SUBJECT: Forwards response to NRC questions re 840402 application  
 for amend to OL.W/three oversize drawings, two being  
 proprietary. One aperture card available in PDR. Two aperture  
 cards available in Central File.

Subject: Responses to NRC Staff Questions  
R. E. Ginna Nuclear Power Plant  
Docket No. 50-244

Attached are responses to NRC staff questions concerning our  
Application for Amendment to Operating License dated April 2,  
1984.

**FIGURE 1-1**

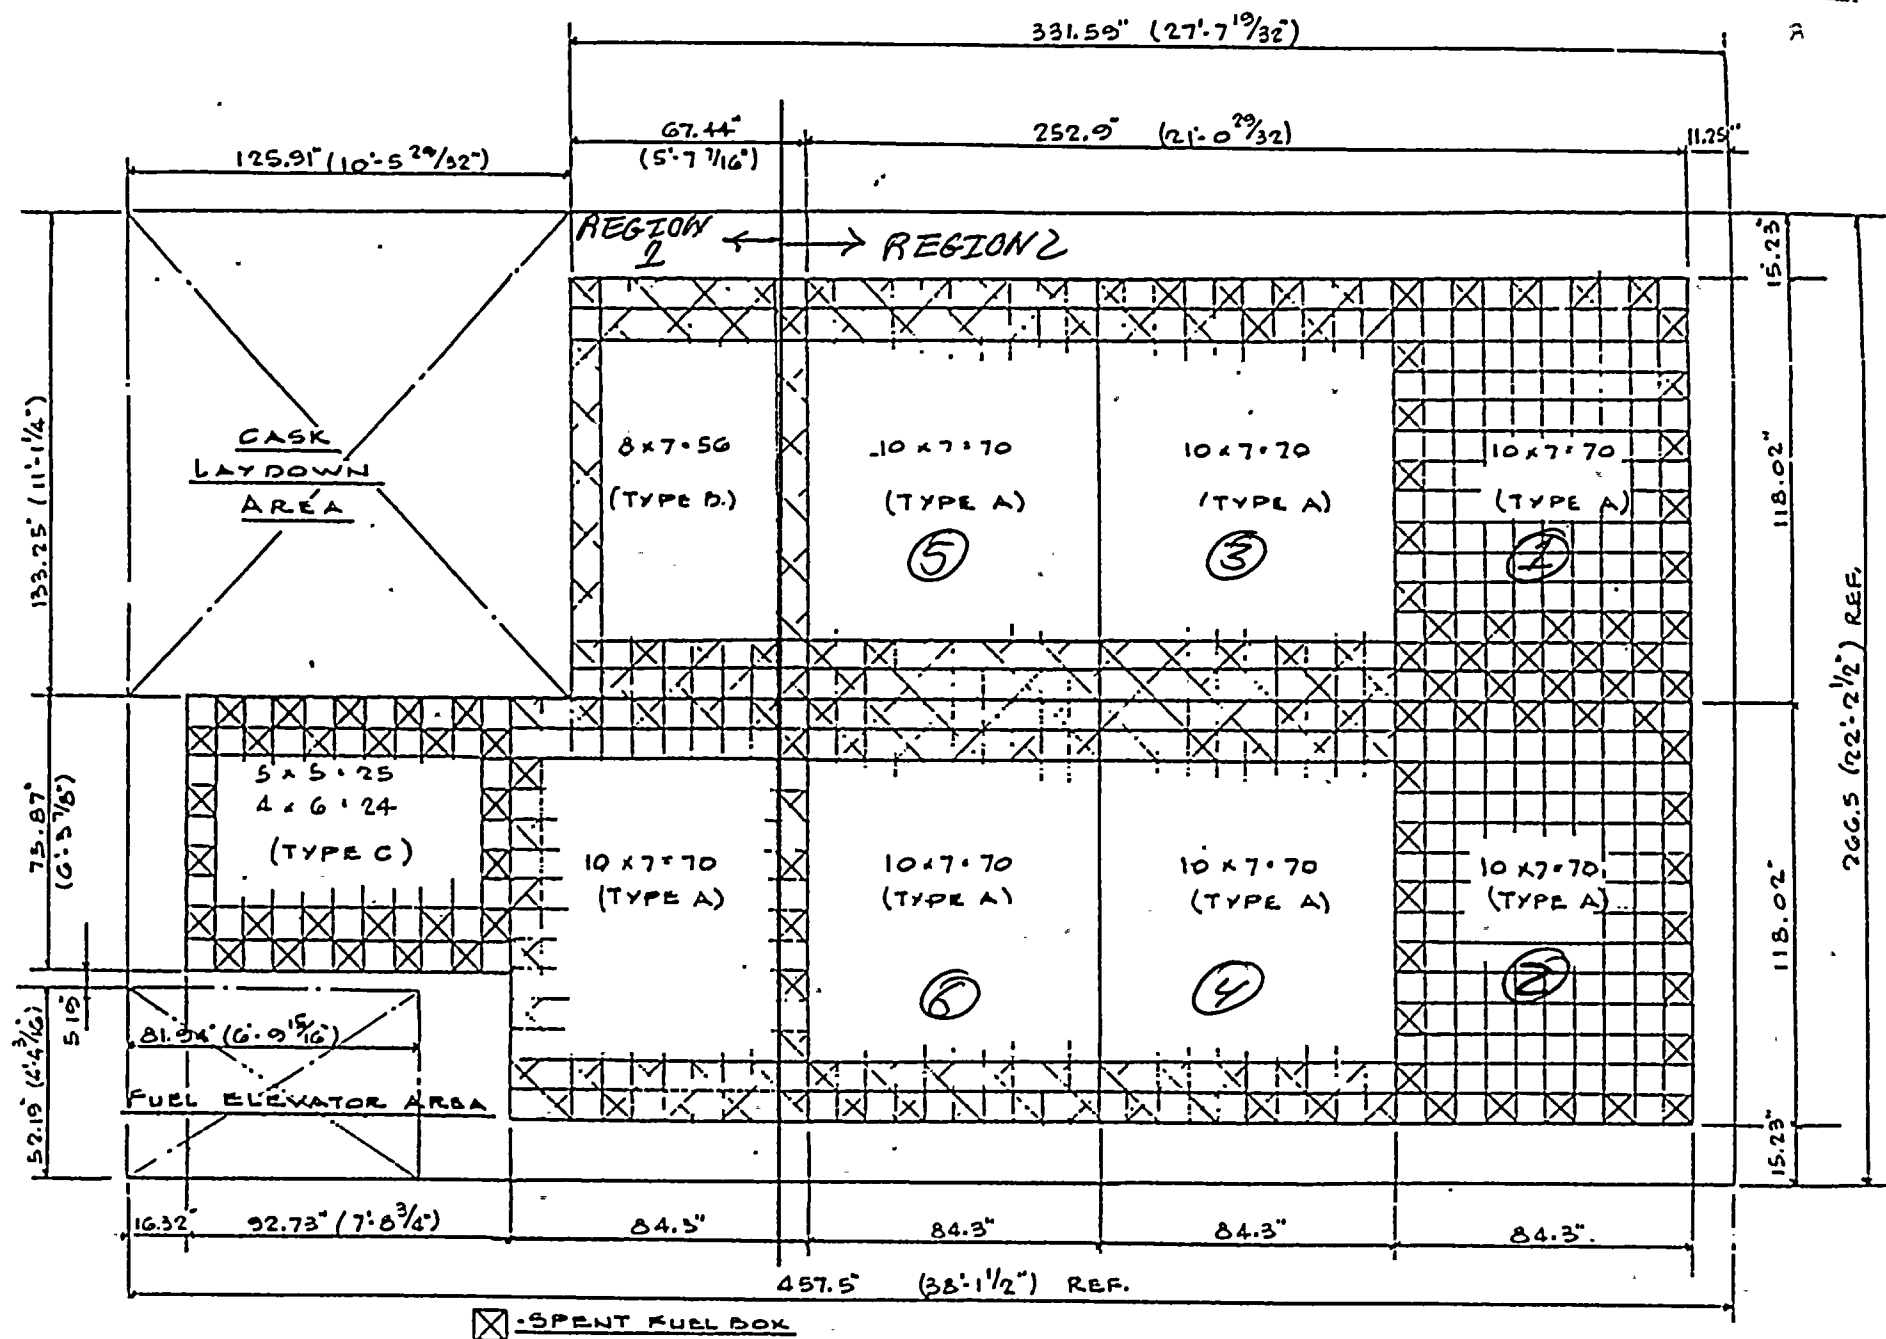
With the aid of drawings describe and discuss the sequence of the steps to be taken during the reracking operations in order to maximize the distance from the stored spent fuel to the area where load handling operations will take place. In addition, demonstrate that a failure of the lifting rig, interposed between the storage rack and the crane hook will not cause the falling rack to tip and impact on stored spent fuel.

The modification will begin with rack #5 as shown on the attached figure. As indicated in an earlier telephone conversation, this sequence is a change from that specified in the submittal. Rack #5 will be moved vertically, then directly south over the decontamination pit (see figure 1-3 of the submittal). At least four empty rows of storage cells will be between the transported rack and any stored spent fuel. This is required for both a margin of safety in case of a load drop, and to minimize exposures to the divers who will be attaching the lifting adapters to the rack. After rack #5 has been decontaminated and moved to the work area by means of a safe load path, rack #3 will be removed and moved to the decon pit. After rack #5 has been returned to the pool and rack #3 moved to the work area, rack #1 will be removed. To remove racks #6, 4 and 2 on the north side of the pool, a load path will be created such that at least 3 empty rows of cells will be between the transported rack and stored spent fuel. An example for removal of rack #6 is attached.

A description of the lifting rig is provided in the response to question 2 and drawing 8369-16. The lifting rig is of a redundant design with each spreader bar independently supported from the crane hook and capable of holding the rack should the other spreader fail. Each spreader supports the rack over the center of gravity, therefore, upon failure of one spreader, the load would remain stable and would not swing.
